*Skunk Creek Floodplain Delineation Study  
FCD 95-16*

## Technical Data Notebook

**SKUNK CREEK  
FLOODPLAIN DELINEATION STUDY**

**FCDMC CONTRACT 95-16**

Hasan Mushtaq

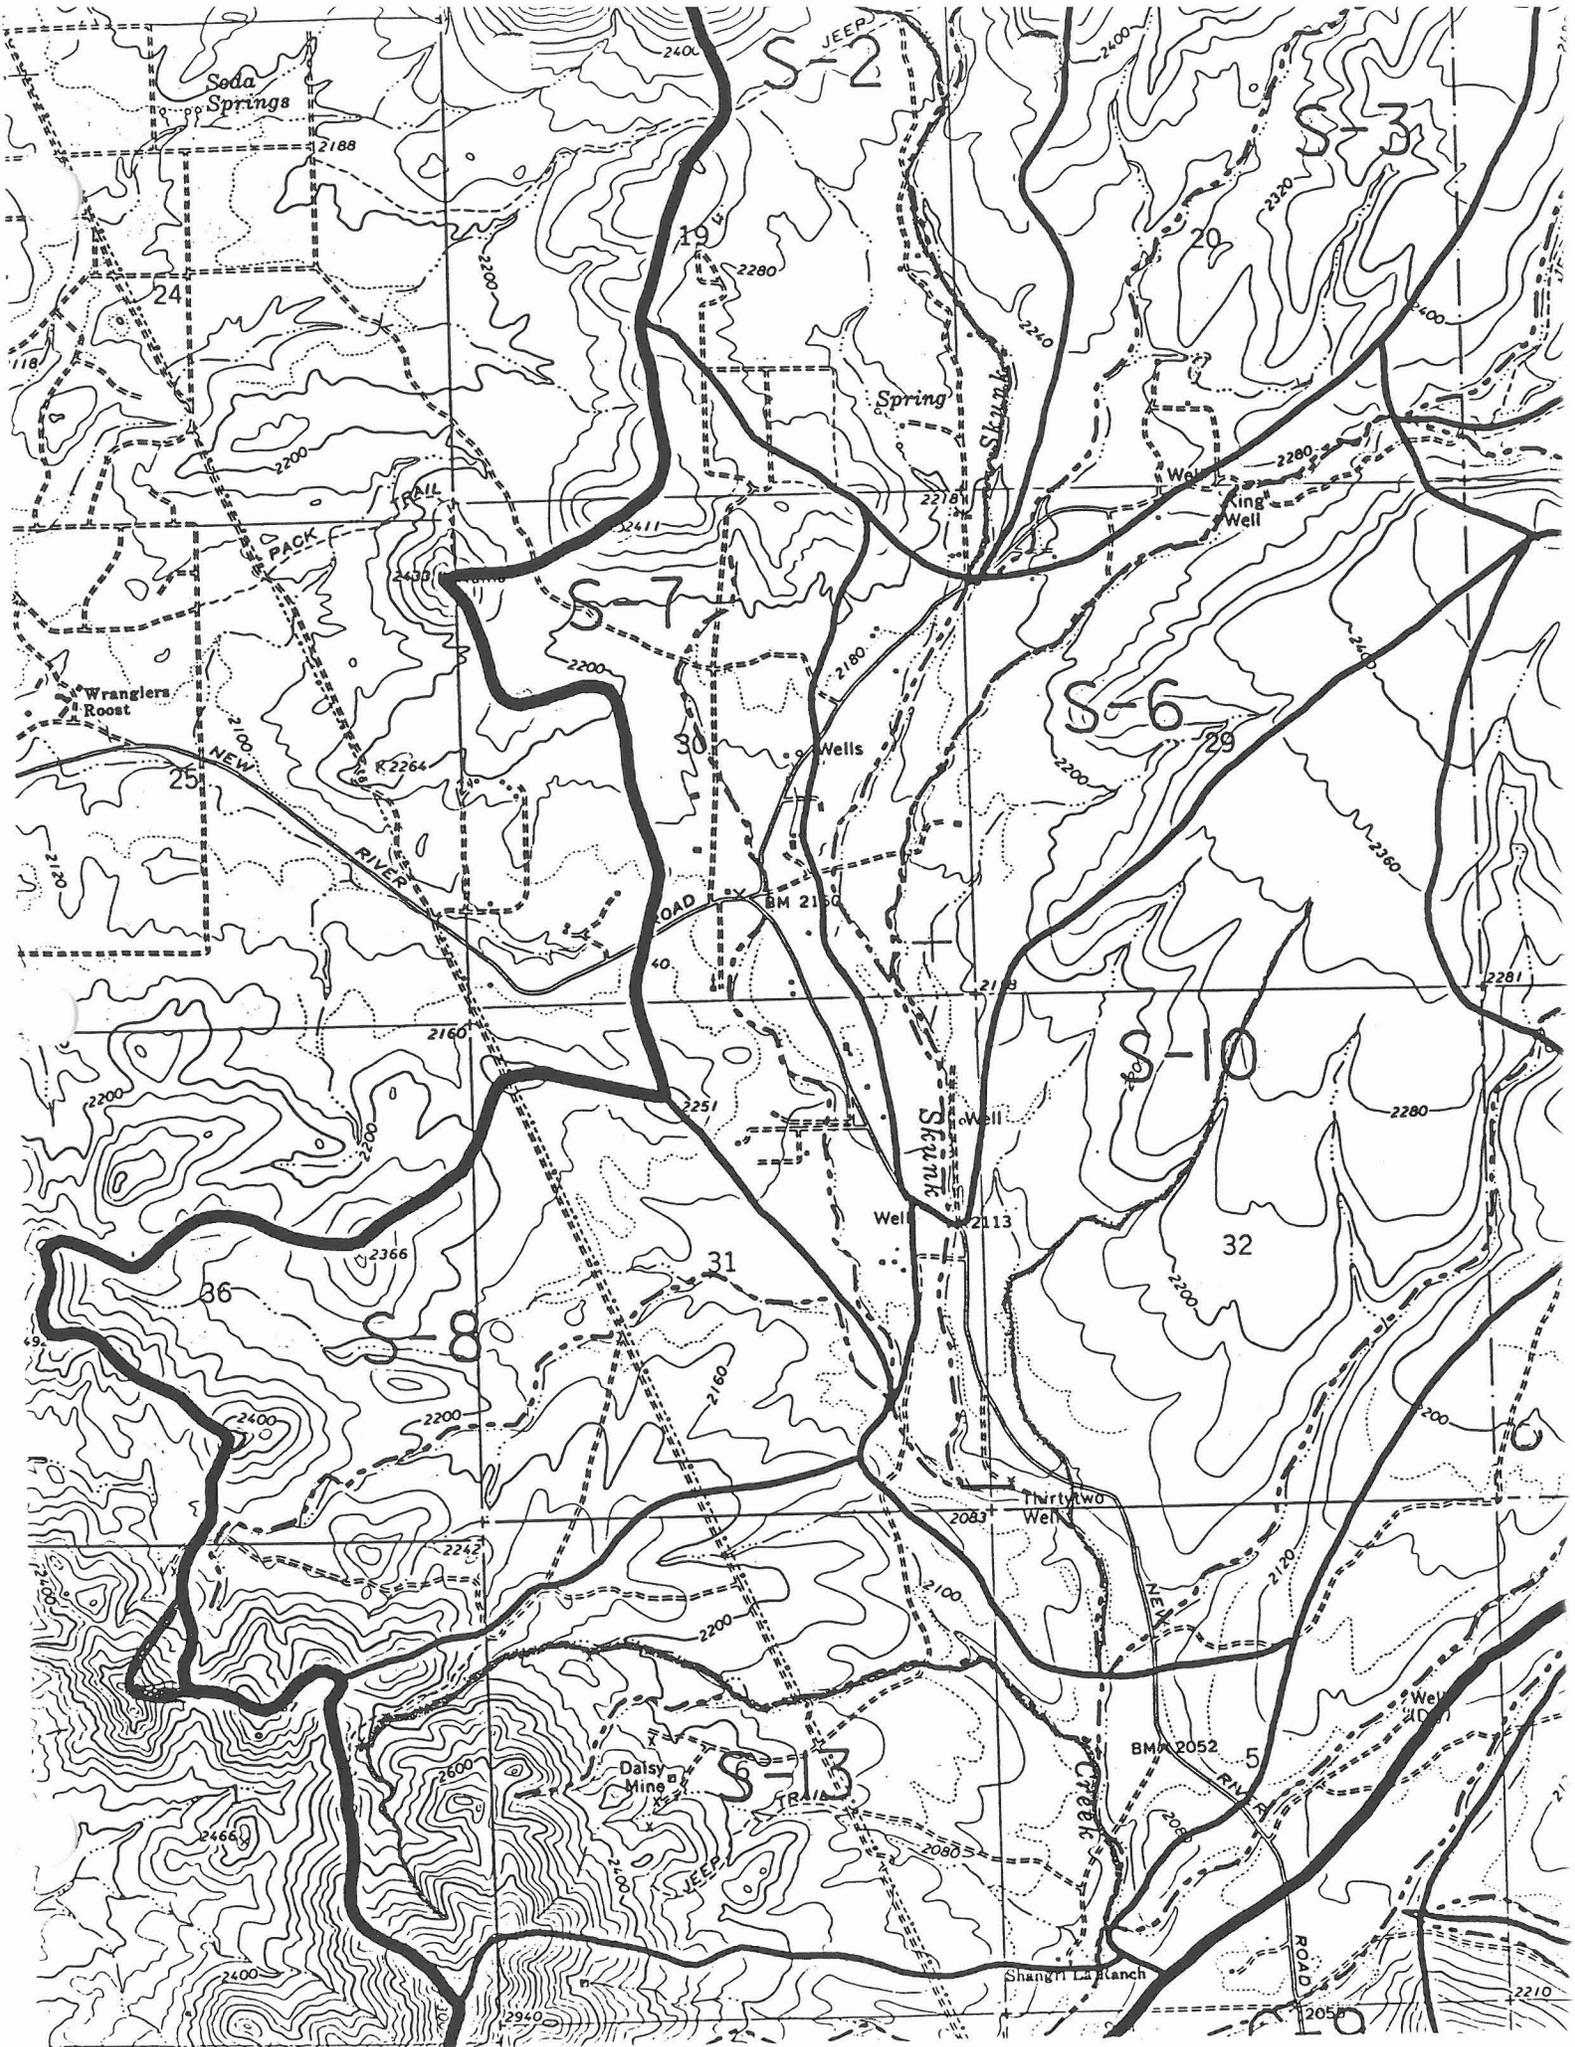
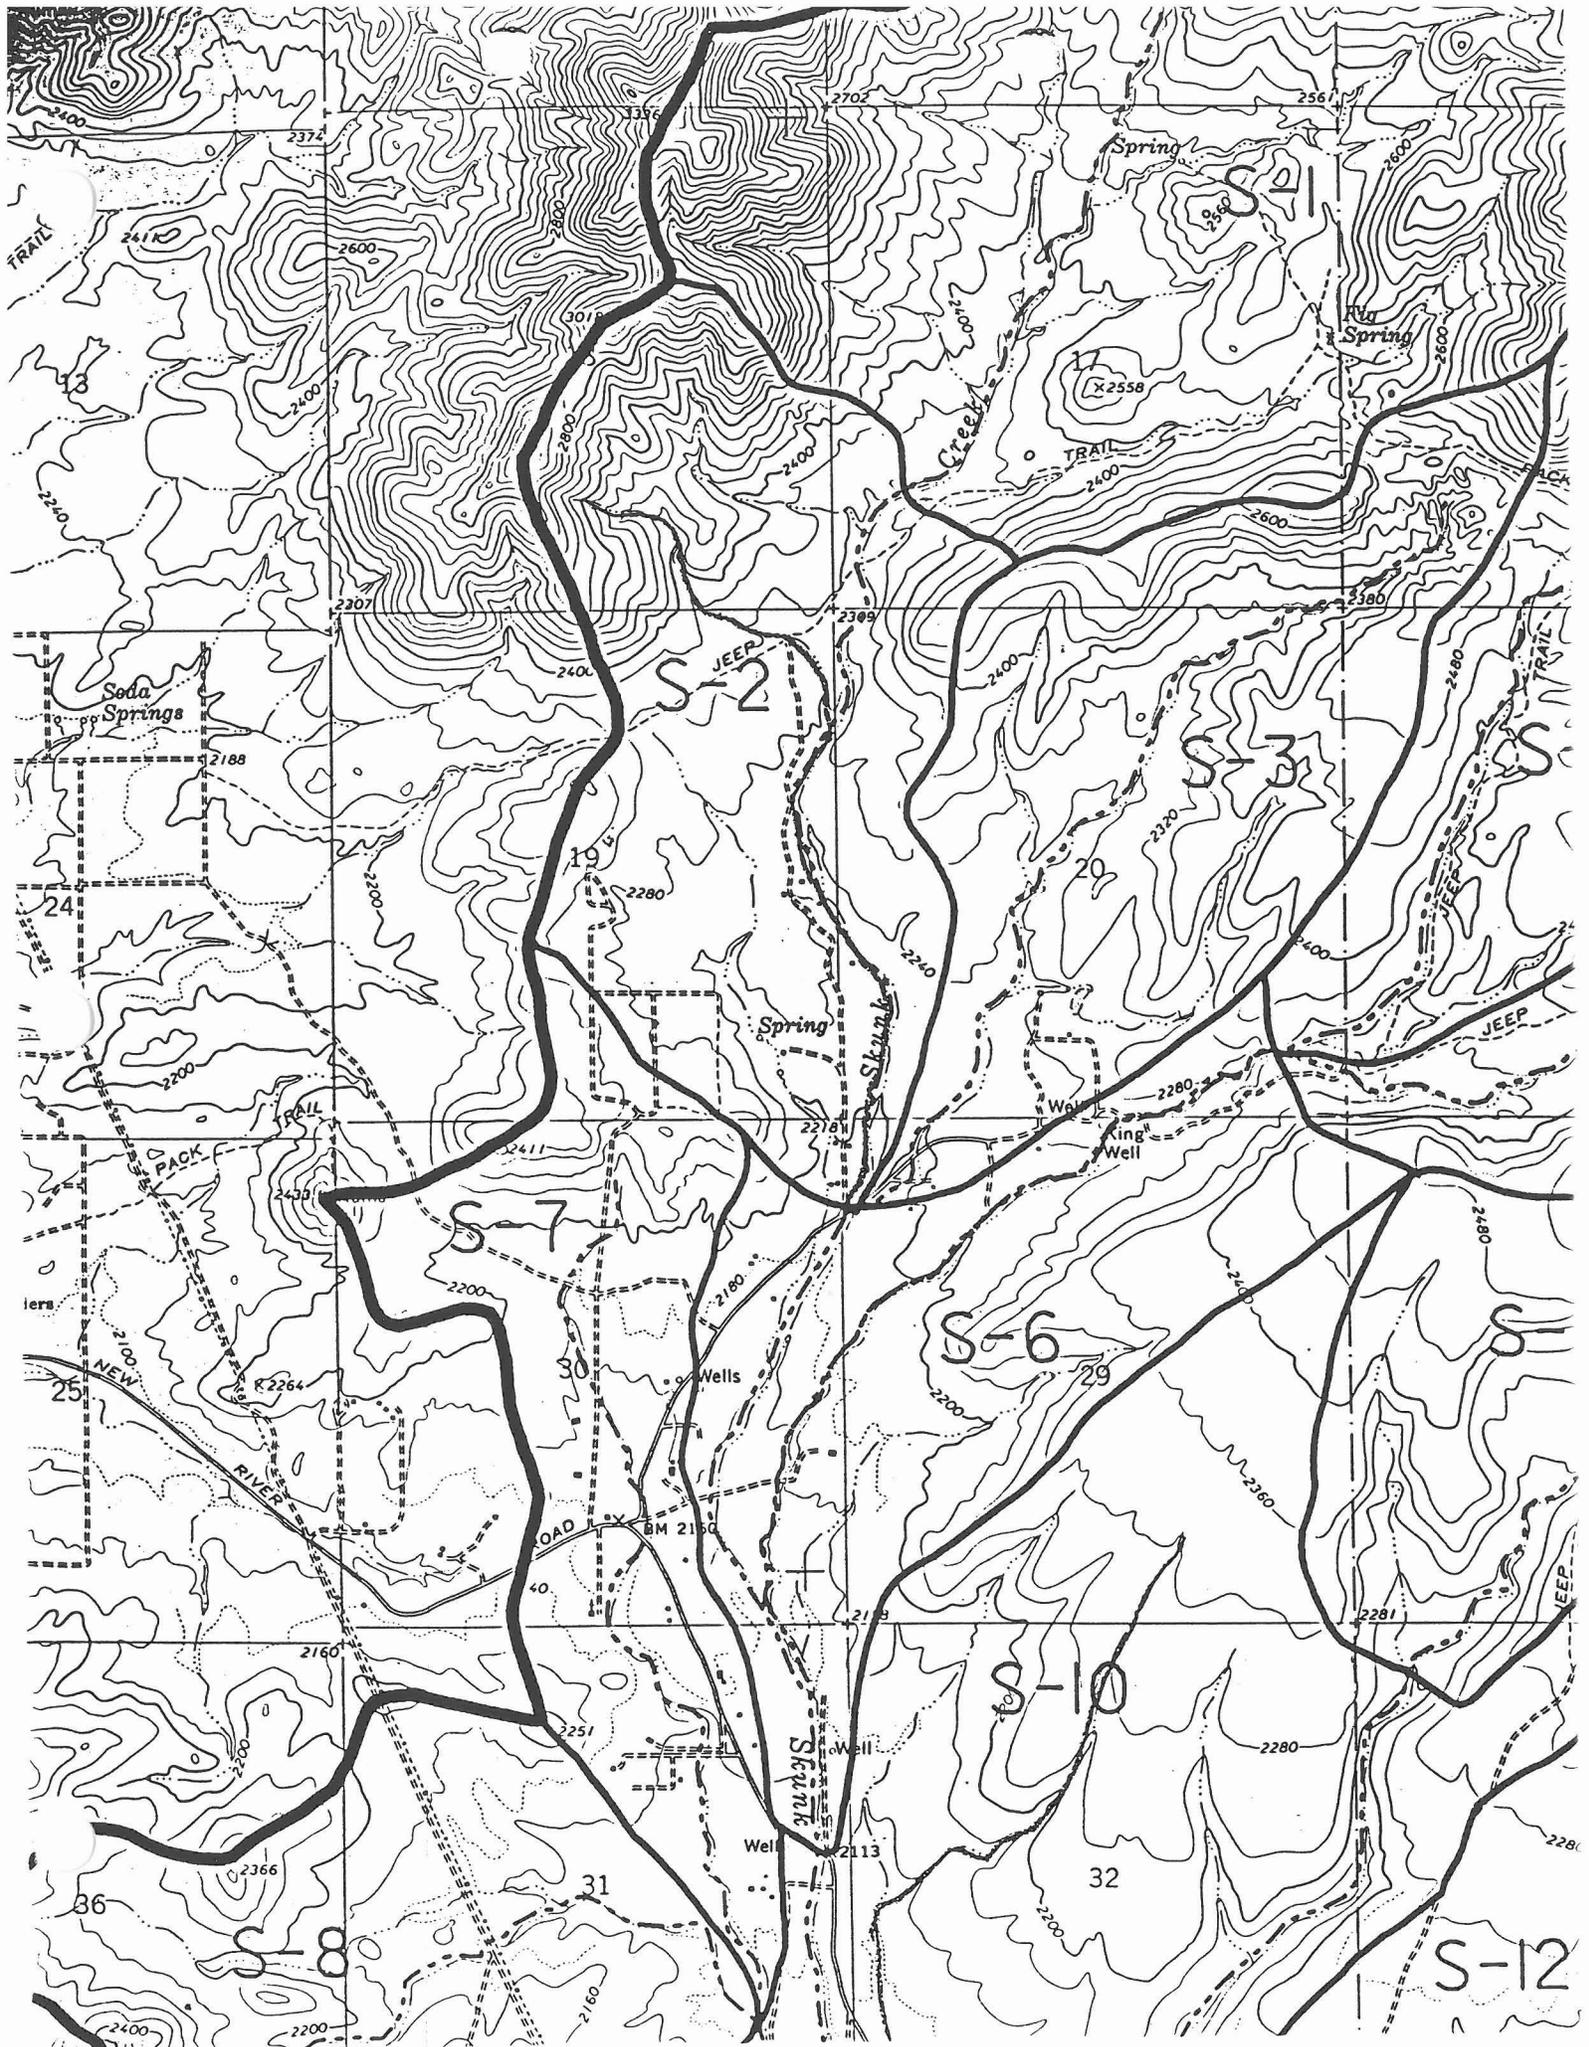
I have completed the review of the subbasin delineation. No significant errors were found. Following are the recommended modifications.

- (1) Please include a proper scale to the watershed subbasin map.
- (2) Subbasins S-2, S-10, S-13, and S-15 may have longer flow paths than shown on the current map (please see attached map).
- (3) It is also recommended that subbasins S-15, S-16, S-17, and U-2 be divided furthermore to create S-15A, S-15B, S-16A, S-16B, S-17A, S-17B, U-2A, and U-2B (please see attached map).
